TXX-2912

COMANCHE PEAK STEAM ELECTRIC STATION
TRANSMITTAL OF MATERIAL REQUESTED
BY QUESTION 032.1
FILE NO. 10010

032.0 INSTRUMENTATION AND CONTROL SYSTEMS BRANCH

Q032.1 Provide a listing of the sections of the FSAR which include the responses to the staff positions and questions transmitted to all applicants with RESAR-3 plants. This transmittal was dated November 17, 1977.

Response These diagrams are given in Figures Q032.1-1 to Q032.1-24.

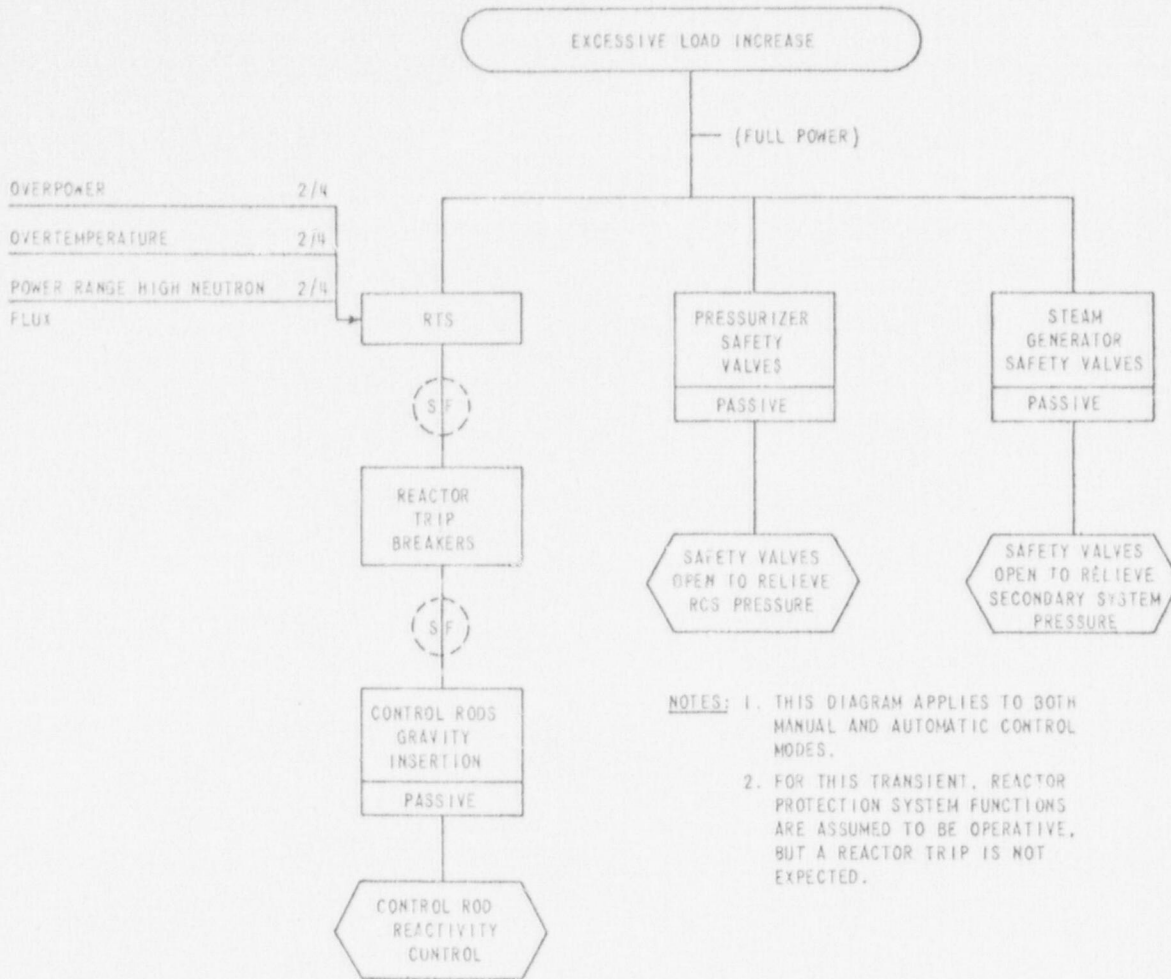
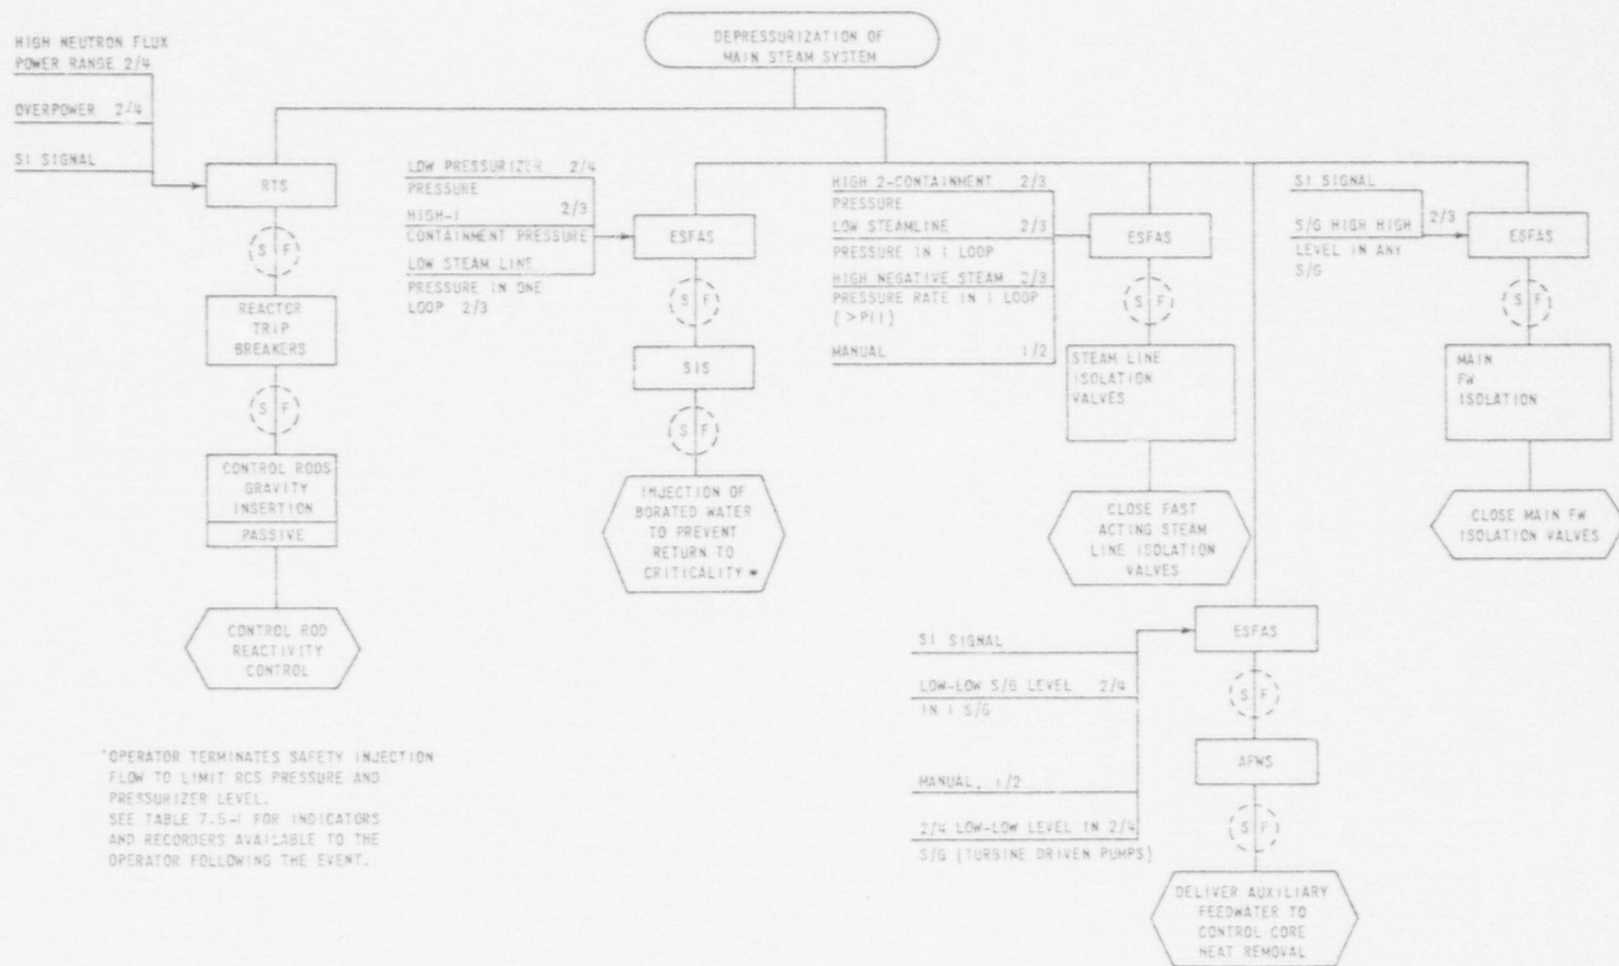
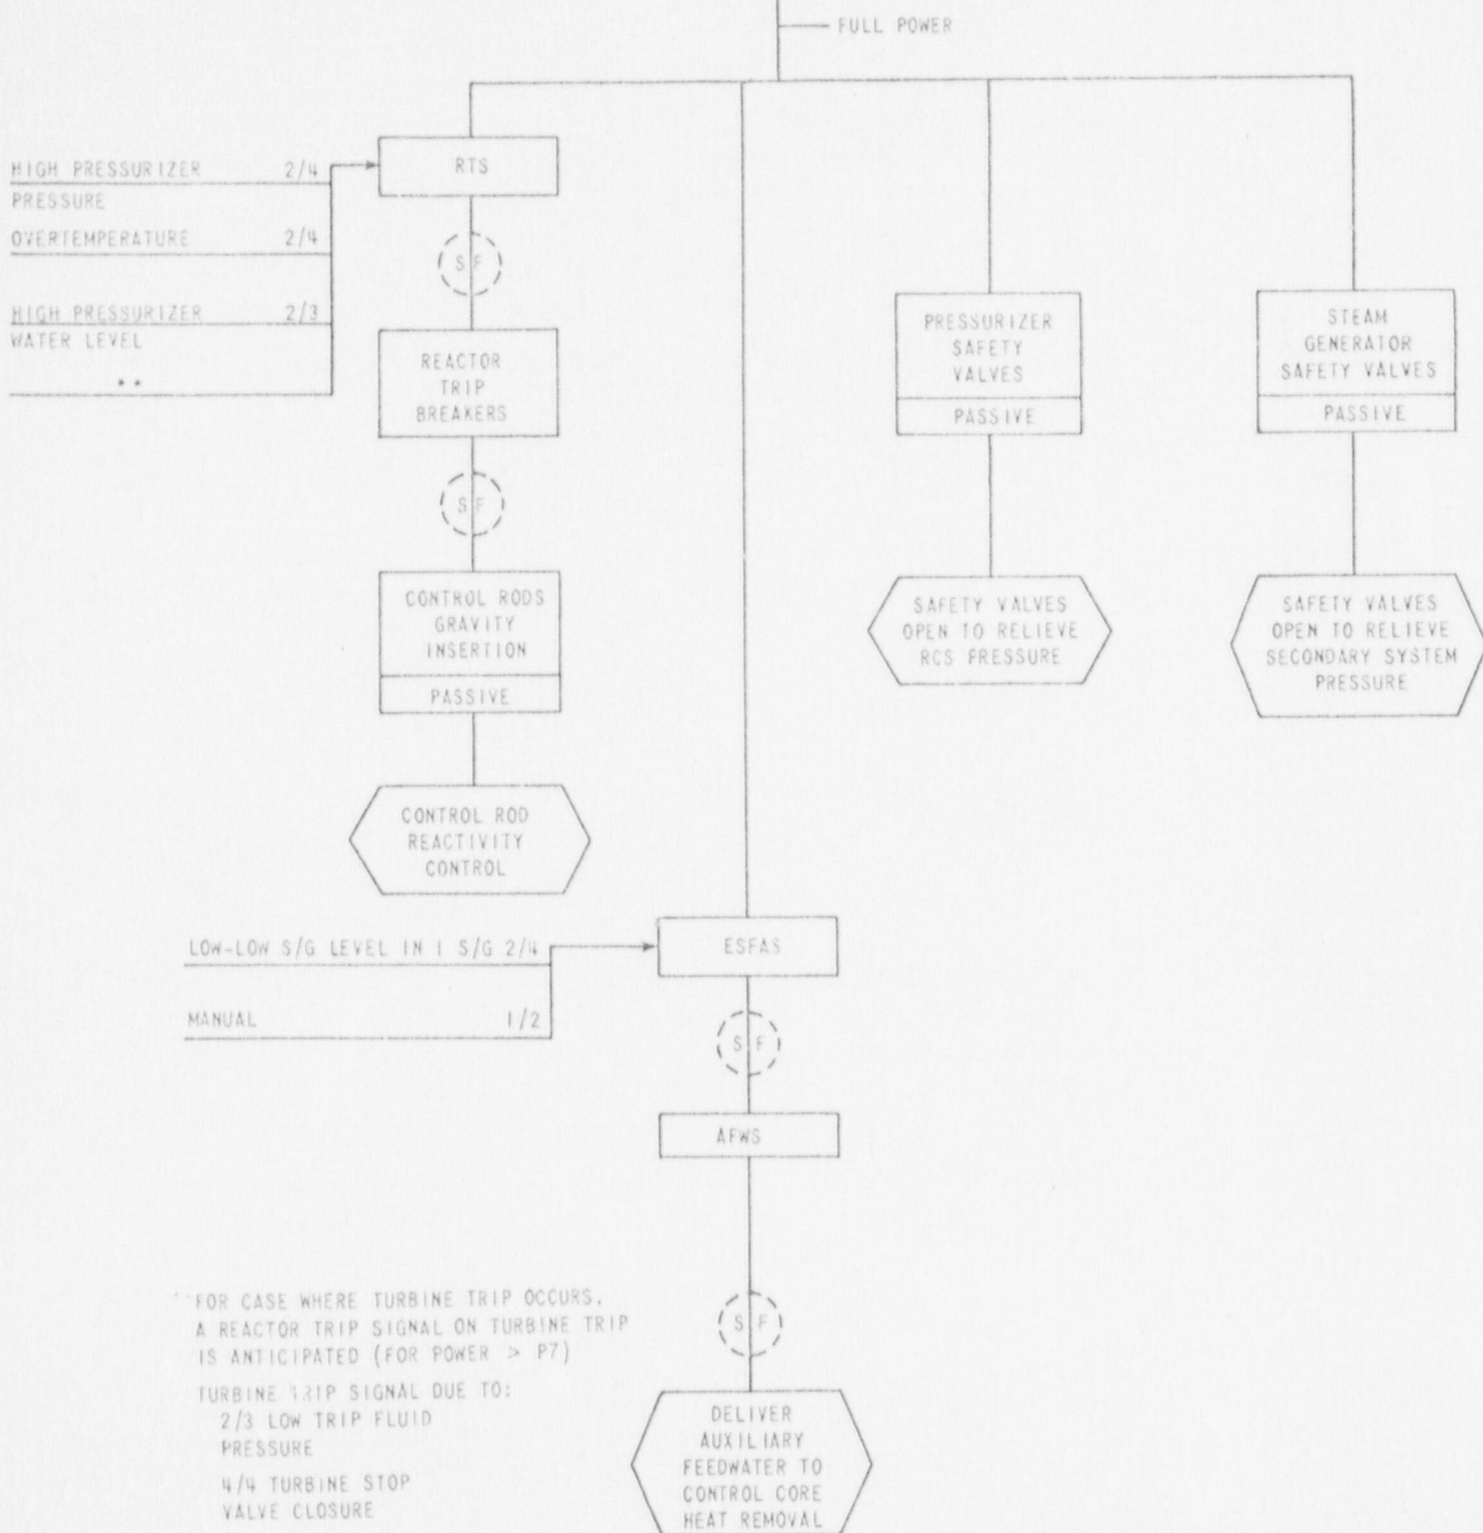
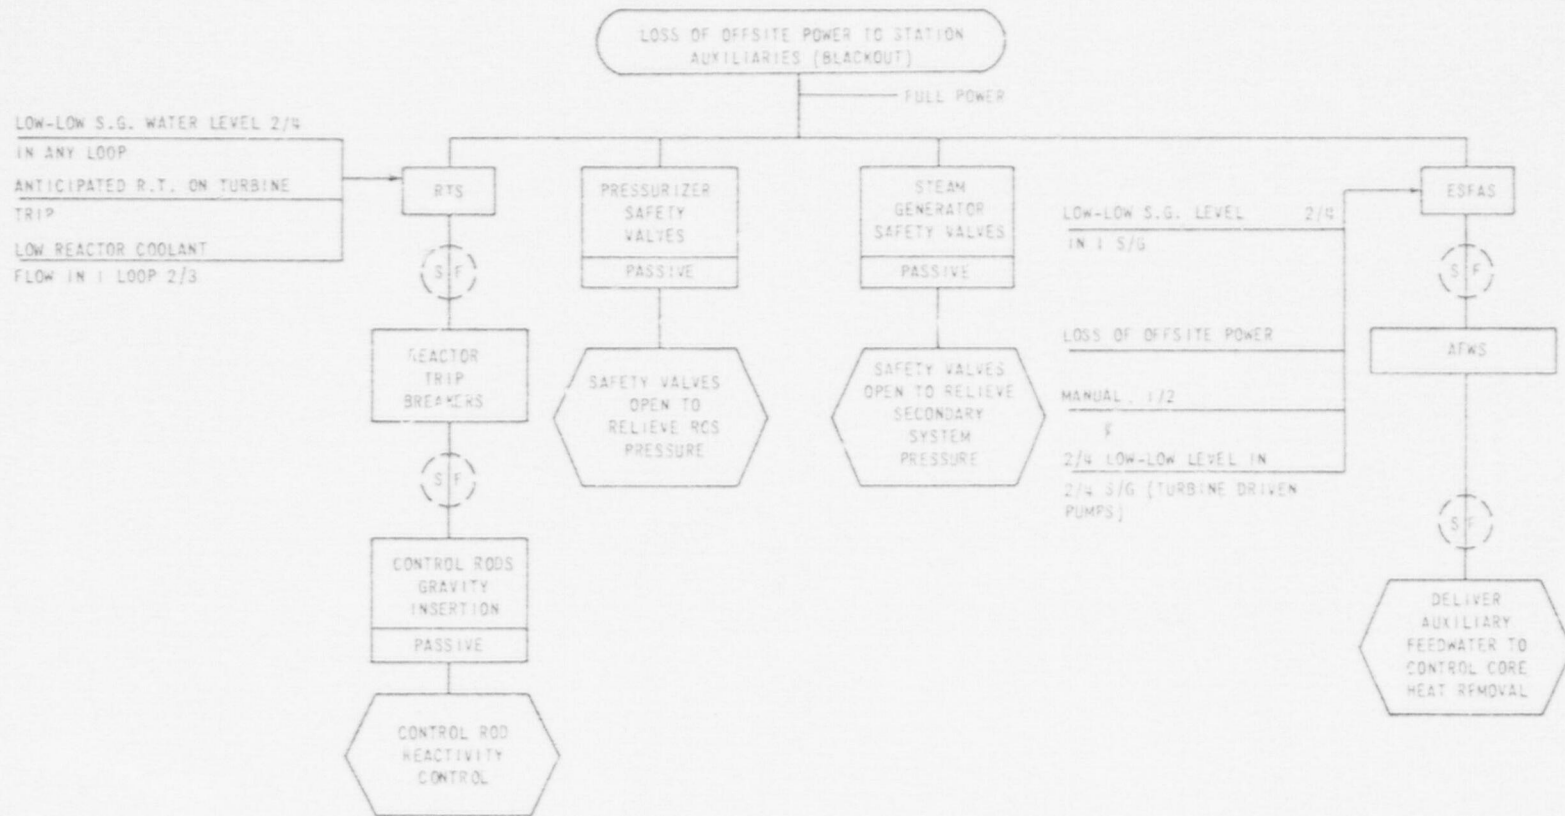
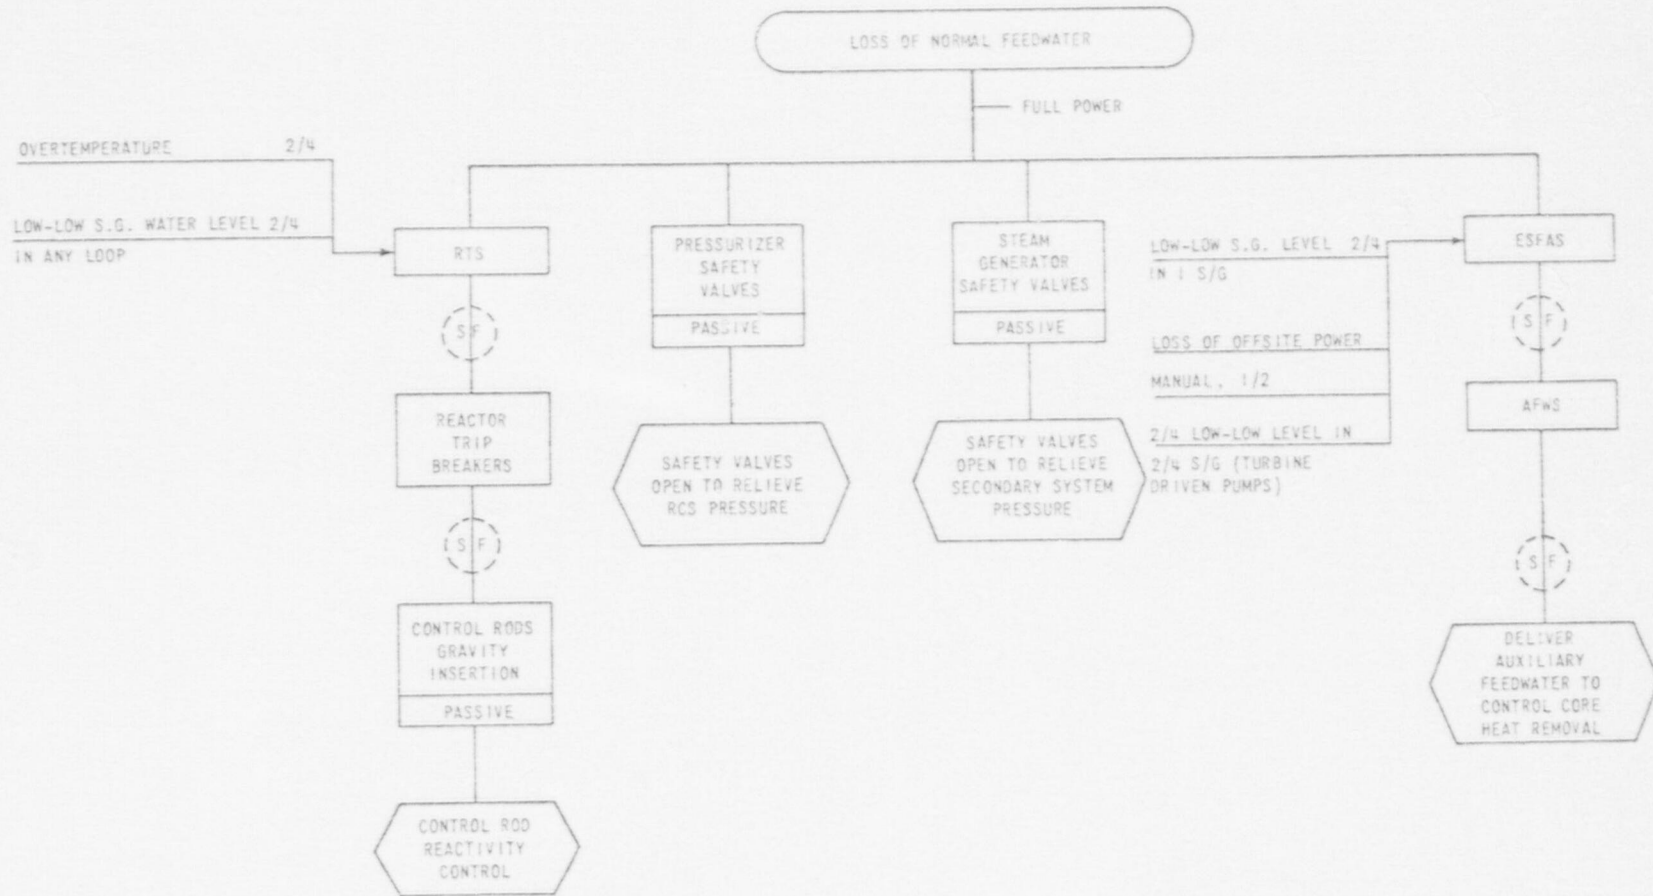
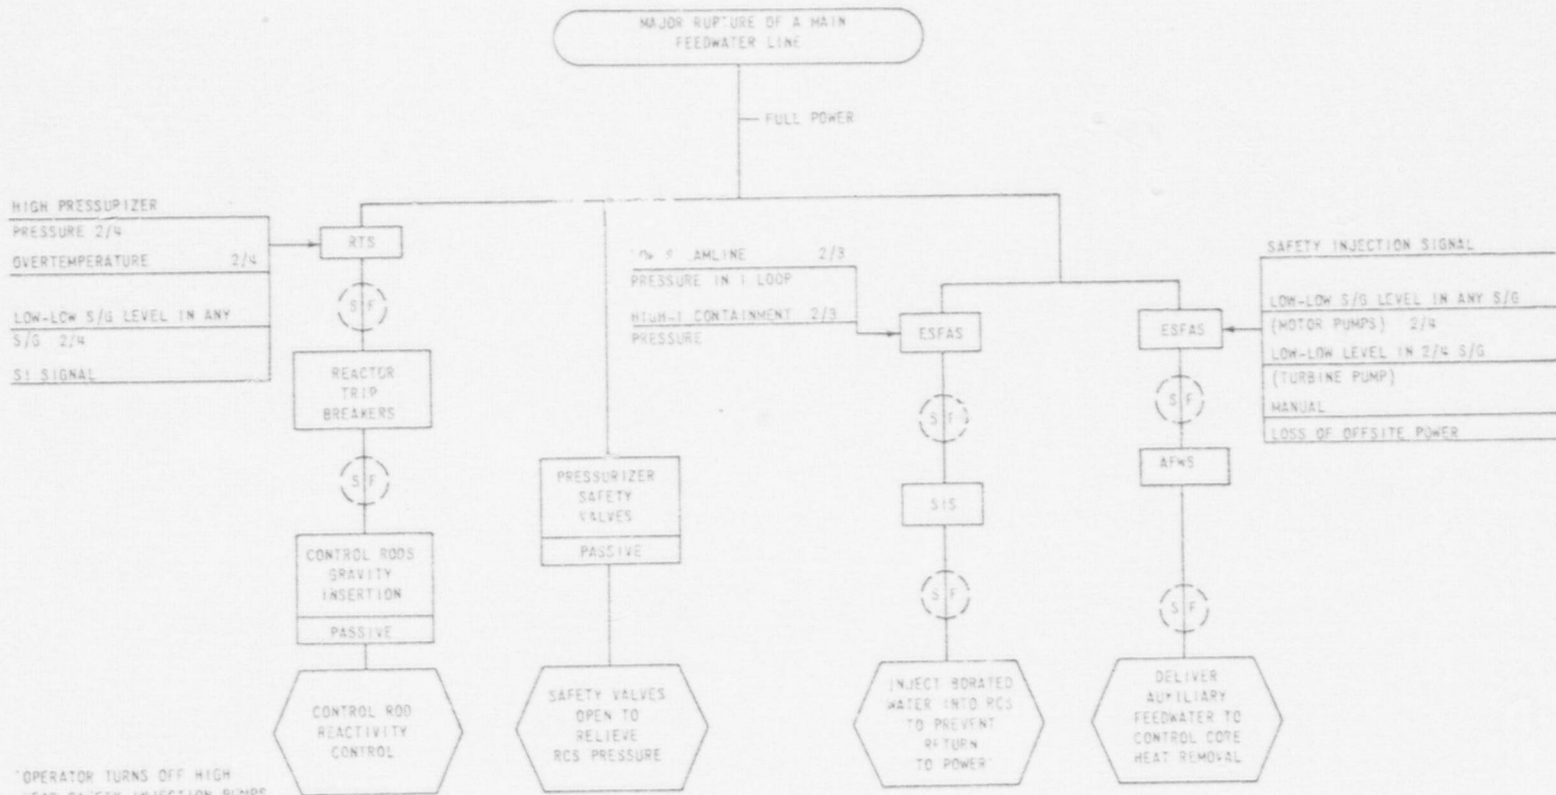
RESAR-3 For each transient and accident analyzed in Chapter 15,
(15.0.1) provide the following information:

- (1) The step-by-step sequence of events from event initiation to the final stabilized condition. This listing should identify each significant occurrence on a time scale, including for example: flux monitor trip, insertion of control rods begin, primary coolant pressure reaches safety valve set point, safety valves open, safety valves close, containment isolation signal initiated, containment isolated, etc. All required operator actions should also be identified.
- (2) The extent to which normally operating plant instrumentation and controls are assumed to function.
- (3) The extent to which plant and reactor protection

systems are required to function.

- (4) The credit taken for the functioning of normally operating plant systems.
- (5) The operation of engineered safety systems that is required.
